## City of Peachtree Corners Town Green Construction Project

RFP #18-004

### Addendum #2

April 27, 2018

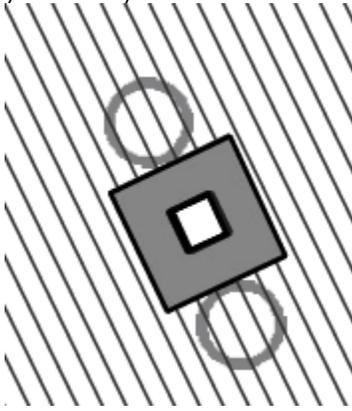
5. With regards to ceramic tile: There is no Ceramic Tile Specification. There is no Material Legend. Please provide product specification for the porcelain wall tile specified for men's & women's bathroom walls.

- Wall Tile – Interceramic – Structura - Ivoire Striped 4 1/4" x 12 3/4"

- Wall Tile – Interceramic – Structura - Ivoire Hammered 4 ¼" x 12 ¾"
  - Wall Tile – Interceramic – Structura - Brune Striped 4 ¼" x 12 ¾"
  - Wall Tile – Interceramic – Structura - Brune Hammered 4 ¼" x 12 ¾"
6. On the spreadsheet "BID DOCUMENT" there are 3 sheds, but we've only counted two on the drawings. Please confirm.  
There are only 2 sheds for this project.
  7. Detail 1/L7.23 calls for a 6' x 8' shed, but all other documents call for 9' x 7', and the manufacturer only produces these in even numbers with smallest being 8' x 8' – please confirm required size.  
6' x 8' is the correct size for the shed.
